Road & Bridge Design Publications

Monthly Update – May 2016

Revisions for the month of **May** are listed and displayed below. New special details will be included in projects submitted for the **August** letting as is stated on the special detail index sheets. E-mail Road related questions on these changes to MDOT-Road-Design-Standards@michigan.gov. E-mail Bridge related questions to MDOT-Bridge-Design-Standards@michigan.gov.

ELEVATION GUARDRAIL, TYPE 4MGS-8

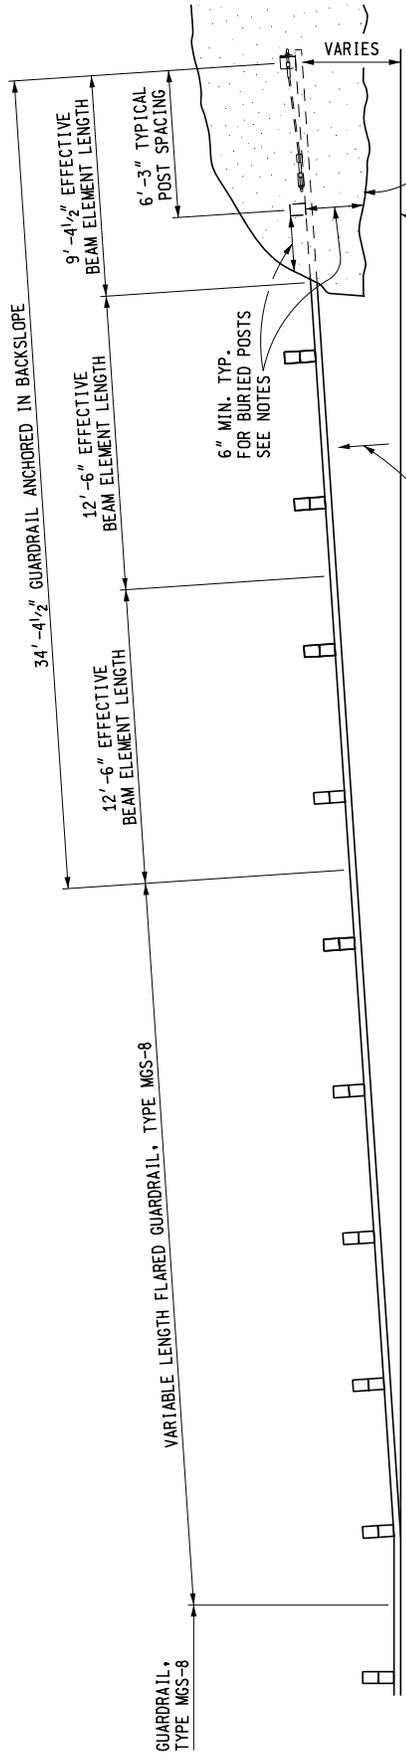
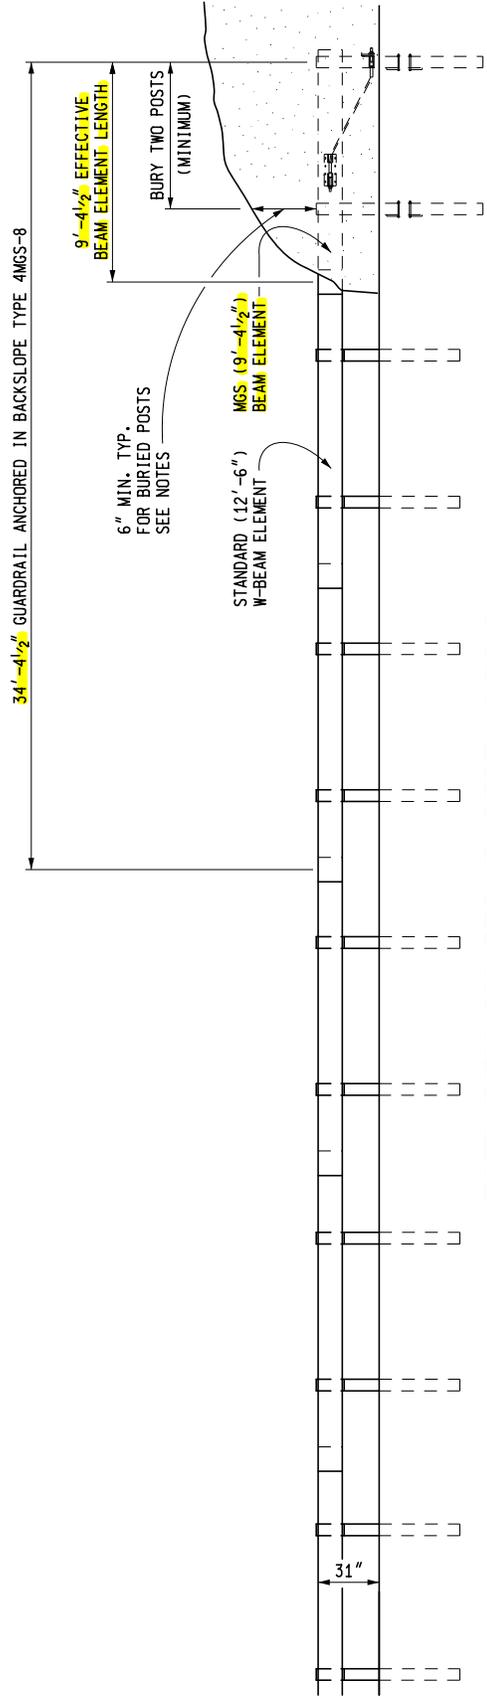
24: Guardrail Anchored in Back Slope Types 4B, 4T, & 4MGS-8: Reduced the length of the Type 4MGS-8 terminal on sheets 2 & 4 from 37'-6" to 34'-4½" using a non-standard beam element (length=9'-4 ½").

ELEVATION SHOWING POST SPACING CONNECTING GUARDRAIL, TYPE MGS-8 OR MGS-8D TO GUARDRAIL, TYPE B, GUARDRAIL, TYPE BD, OR GUARDRAIL APPROACH TERMINAL TYPE 1B, 2B, OR 3B

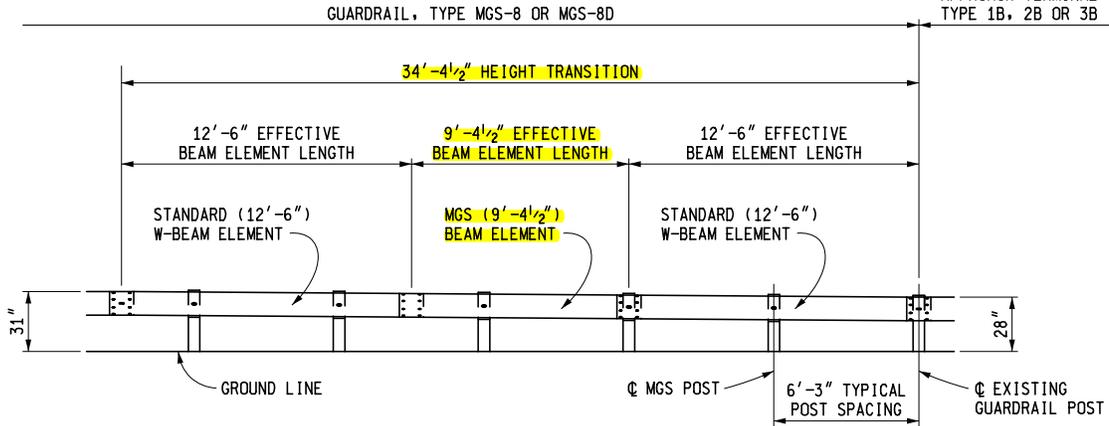
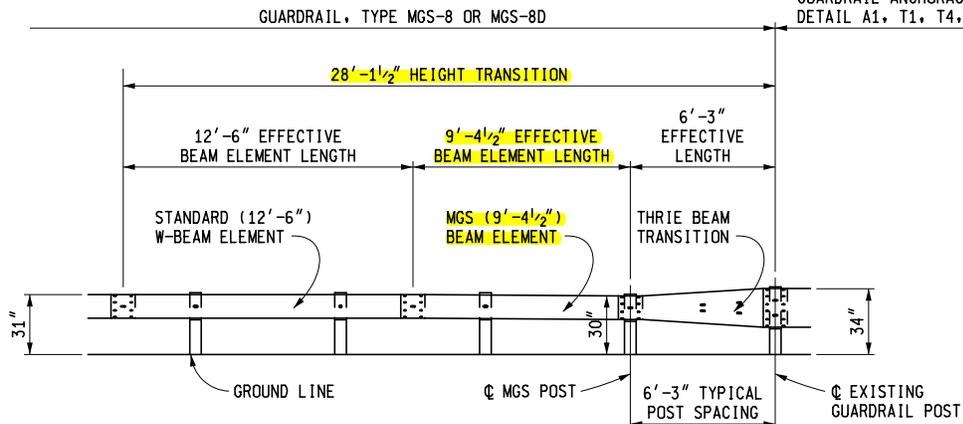
R-60-J: Guardrail Types A, B, BD, T, TD, MGS-8, & MGS-8D: Reduced the length of the transition from guardrail Type MGS to guardrail Type B or T by 3'-1½" (sheet 10) using the non-standard beam element (length = 9'-4 ½") on sheet 11.

POST PLACEMENT DETAIL

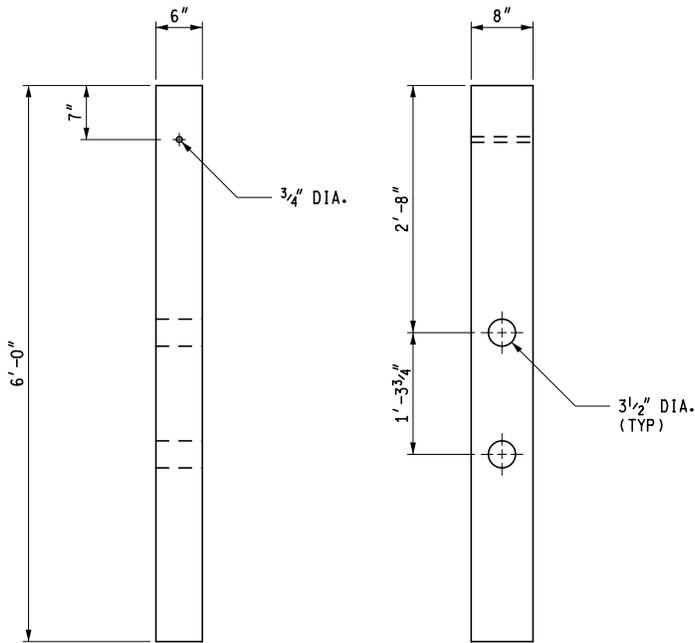
R-72-D: W-Beam Backed Guardrail & Guardrail Long Span Installations: Deleted the 2'-8" offset from the face of the post to the hinge point in the detail at the top of sheet 8, since it is only applicable to the MGS long span details.

6.29.06A

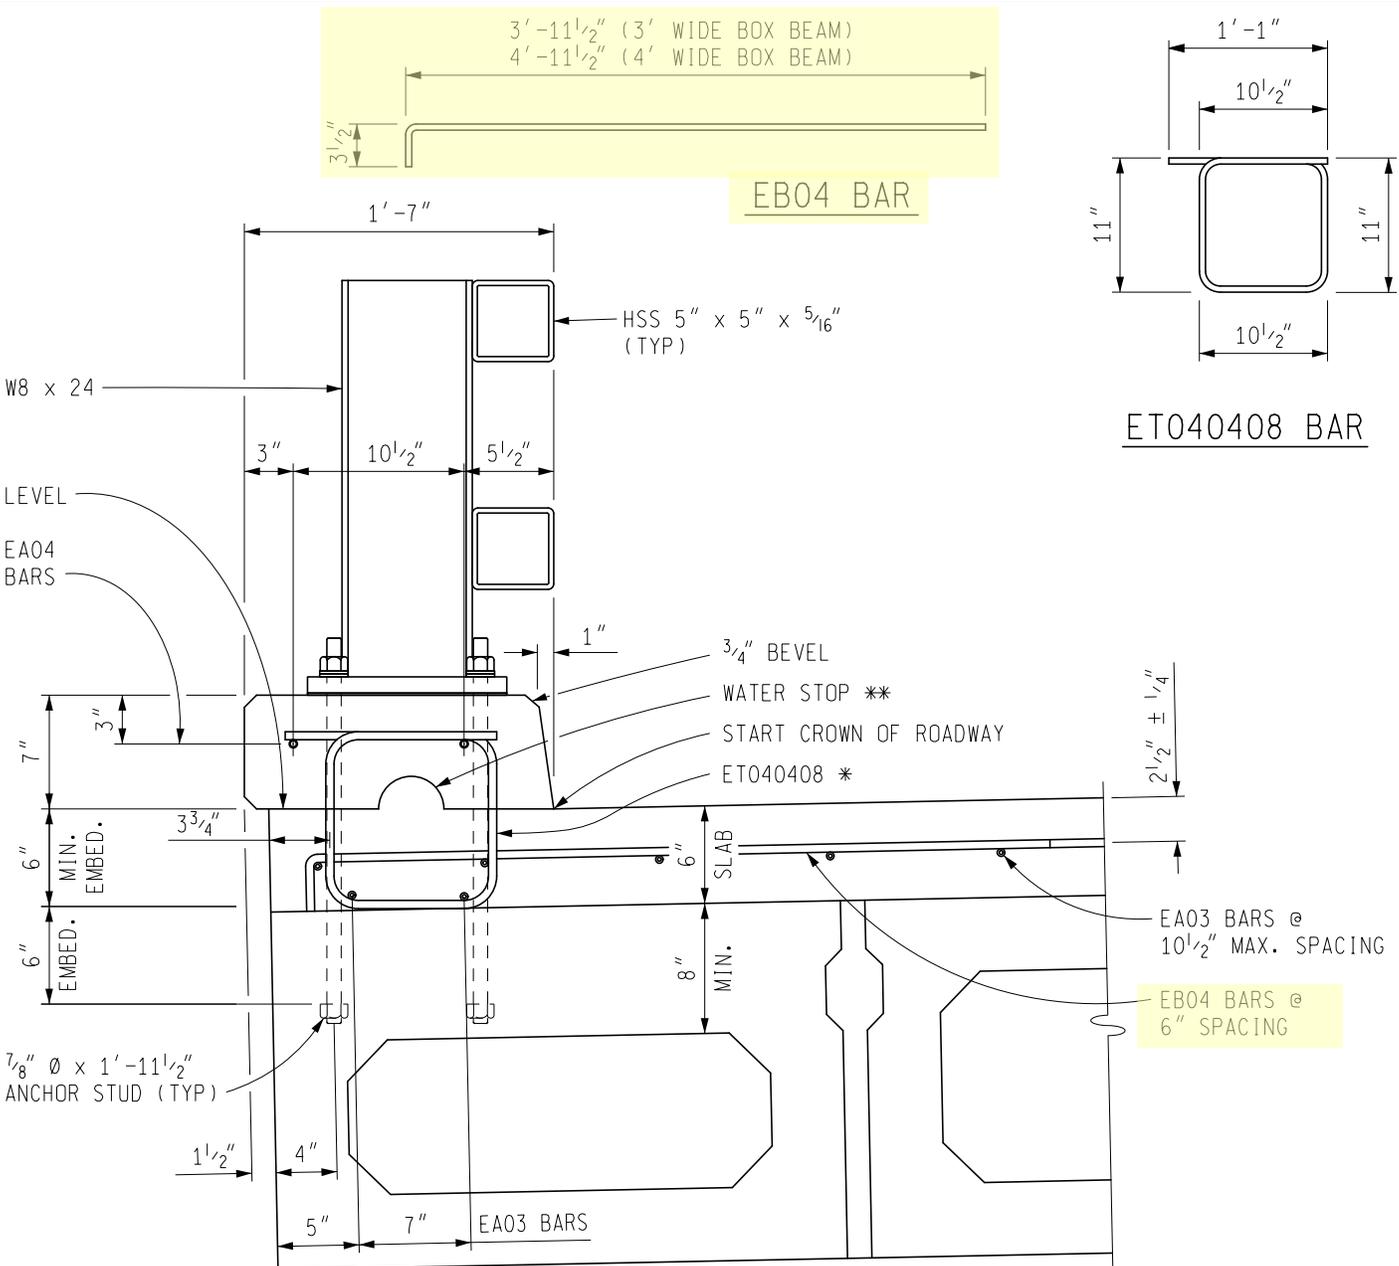
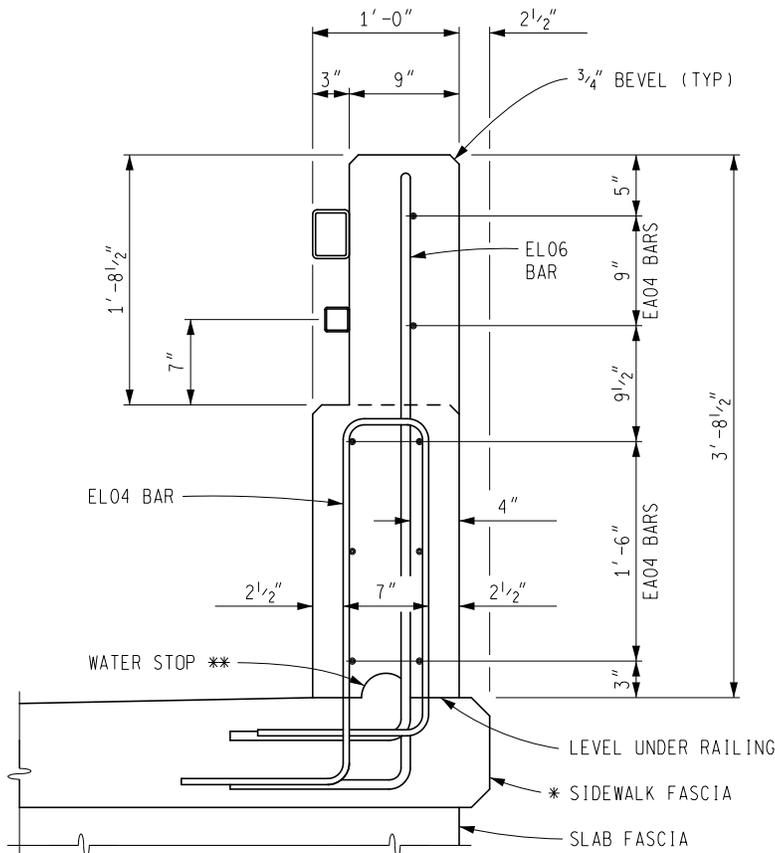
6.29.06A: Revised EA04 bars to EB04 bars at fascia and under railing.

6.29.10B

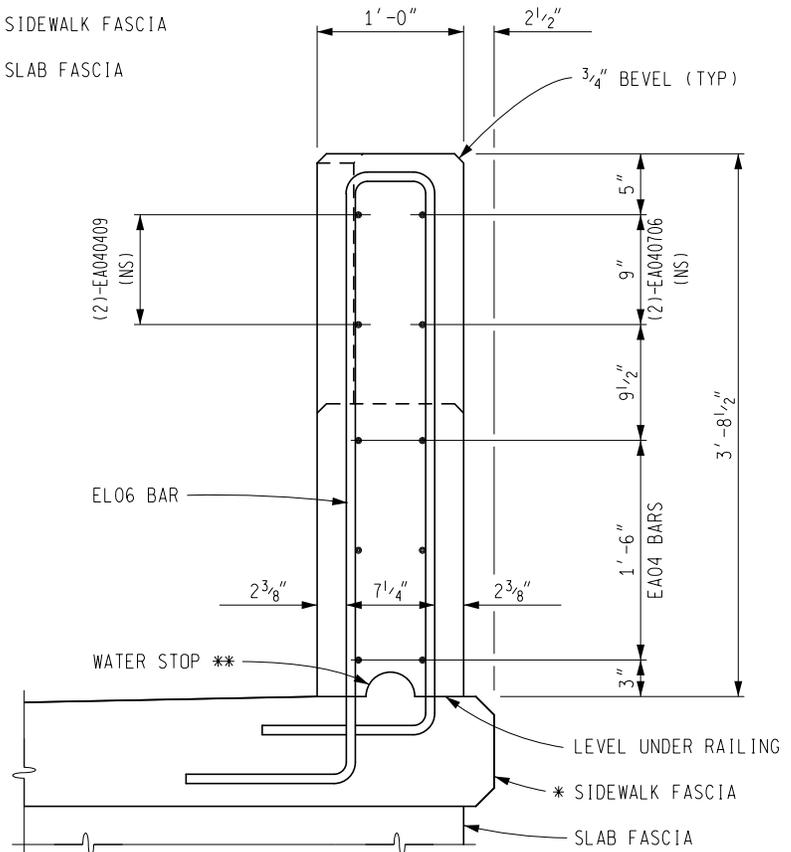
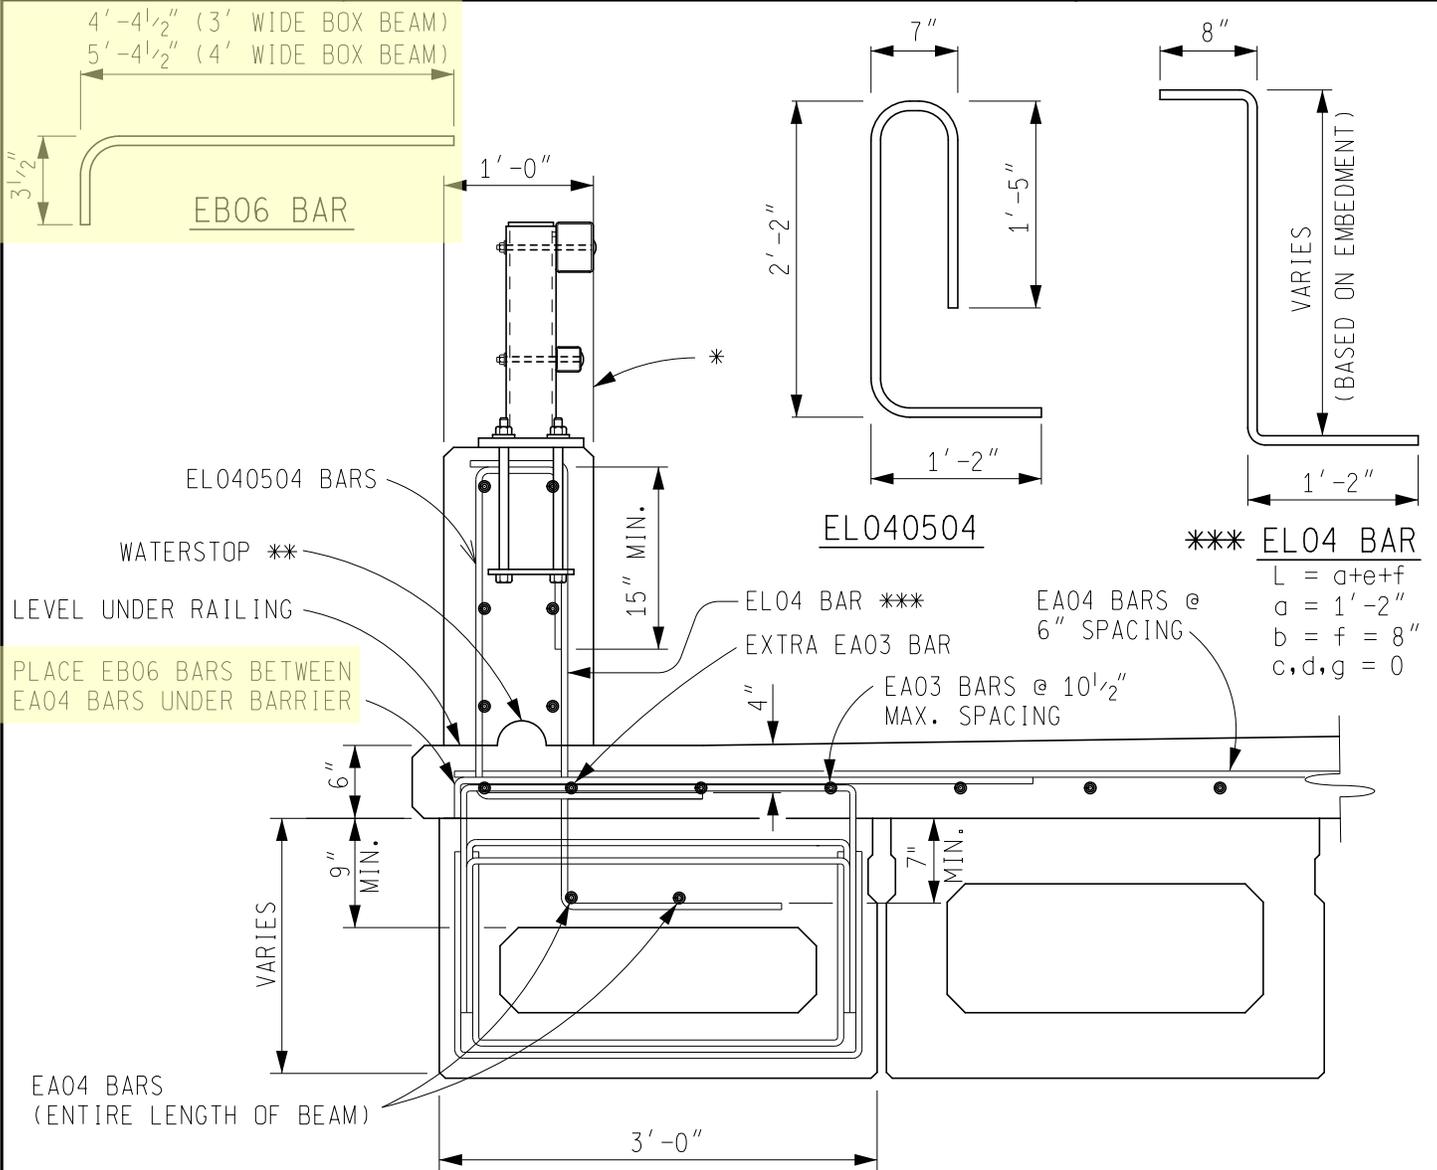
6.29.10B: Added note to use waterstop only when railing is mounted flush to the slab.

** 2" HIGH x 4" LONG (±). FORMING NOT REQUIRED. USE WHEN RAILING IS MOUNTED FLUSH TO THE SLAB.

6.29.10D

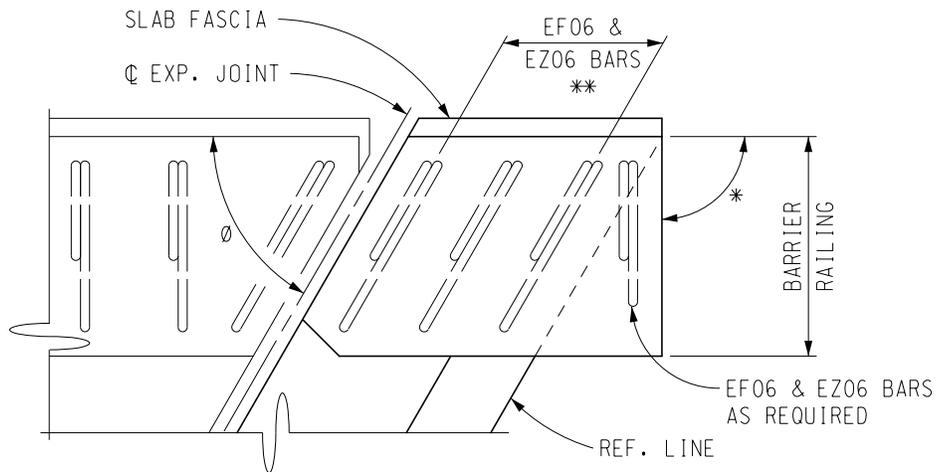
6.29.10D: Added dimensions for EB06 bar for 4 foot wide box beams.

6.29.16A

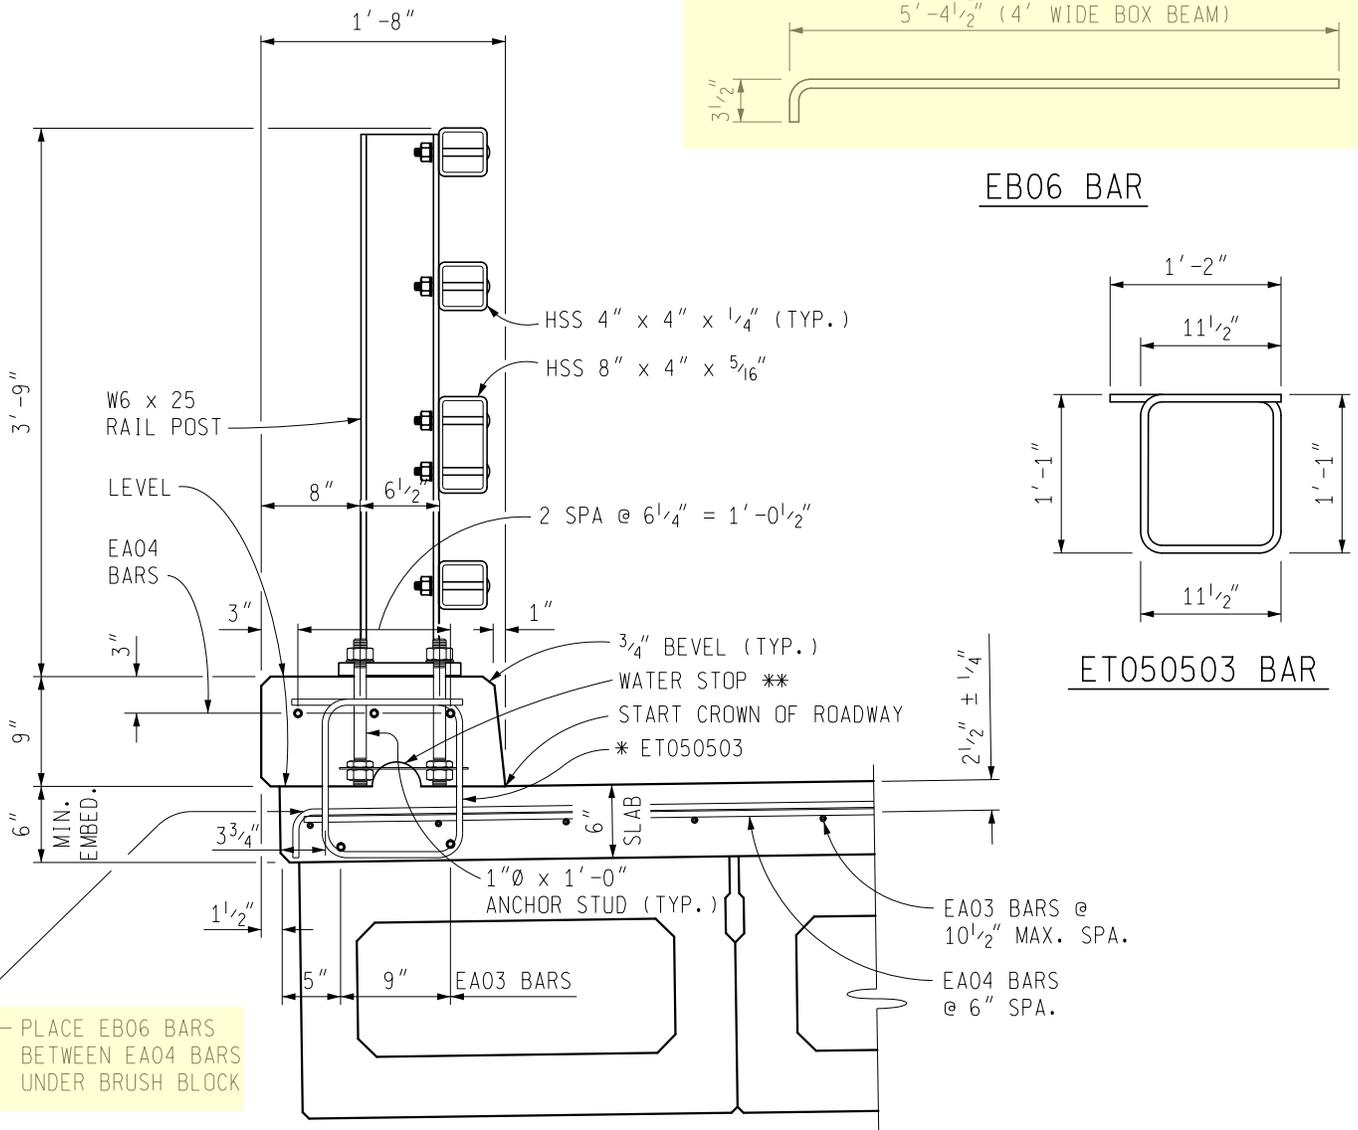
6.29.16A: Added waterstop to section A-A.
